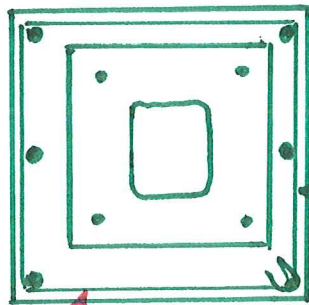
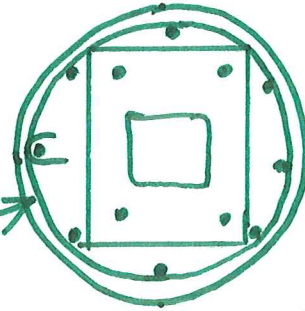
CAN THIS  
TIE BE USED  
TO BOTH  
SATISFY  
7.10.5.17 +  
CARRY  
SHEAR  
FORCE?  
(VIA ENCLOSING  
ANCHOR GROUP  
+ BEING  
DEVELOPED  
BEYOND  
THE BREAKOUT  
SURFACE?)
